**Re: Incorrect Thermal broken Aluminum Joinery: 2 Rapare St. Job No.27363 - JSR Construction.**

----- Forwarded message -----  
From: **Matt McLelland** <matt.mclelland@hagley.co.nz>  
Date: Thu, Nov 24, 2022 at 12:37 PM  
Subject: 27363 - 2 Rapera Street  
To: Ricky Wong <jsrconstruction.nz@gmail.com>  
Cc: Tom Ashwin <tom.ashwin@hagley.co.nz>

Photo 6 – Indicating the non-thermally broken parts of the Sliding Door “Bedroom 3 D5” (Door

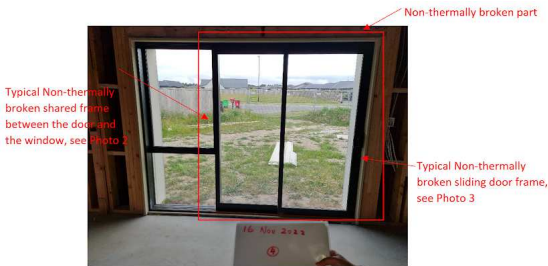
- f) Photo 6 – Indicating the non-thermally broken parts of the Sliding Door “Bedroom 3 D5” (Door number referred to the attached quote no. 27363) (Trim Size: 2130 x 1800; Area: 3.834 m sq.)

Photo 7 – Indicating the non-thermally broken parts of the Sliding Door “Bedroom 2 D4” (Door number referred to the attached quote no. 27363) (Trim Size: 2130 x 1800; Area: 3.834 m sq.)

Photo 9 – Indicating the non-thermally broken parts of the Sliding Door “Master Bedroom D3” (Door number referred to the attached quote no. 27363) (Trim Size: 2130 x 1800; Area: 3.834 m sq.)

Photo 12 – Indicating the non-thermally broken parts of the Sliding Door “Bedroom 4 D4” (Door number referred to the attached quote no. 27363) (Trim Size: 2130 x 1800; Area: 3.834 m sq.)

Photo 8 – Indicating uncertain thermally broken window “Bedroom 2 W5” (Door number referred to the attached quote no. 27363) (Trim Size: 600 x 2400; Area: 1.37 m sq.)

Photo 10 – Indicating uncertain thermally broken window “Master Bedroom W4” (Door number referred to the attached quote no. 27363) (Trim Size: 600 x 2400; Area: 1.37 m sq.)

Photo 11 – Indicating uncertain thermally broken window “Master Bedroom W3” (Door number referred to the attached quote no. 27363) (Trim Size: 1000 x 1500; Area: 1.5 m sq.)

Figure 1 - Photo location plan

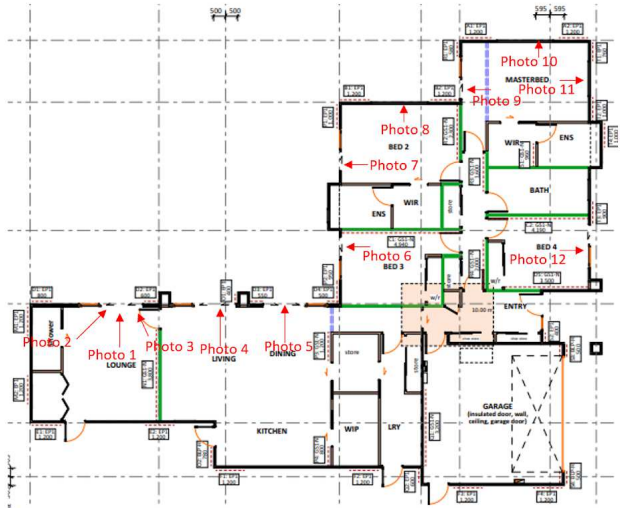
You shall provide us with all the satisfied up-to-standard thermally broken aluminium joinery. You are requested to replace and re-install all the incorrect entire window doors. Partly replacement of aluminium materials on the site is not acceptable. You are also liable for all our losses of cost including but not limited to the related the material reinstatements, any material variations, any time delay and any opportunity costs incurred by the correction of the aluminium windows and doors. The incorrect and uncertain products are stated below with the corresponding photos and the photo location plan (Figure 1 below). The product quote no. 27363 from your subcontractor attached for your reference.
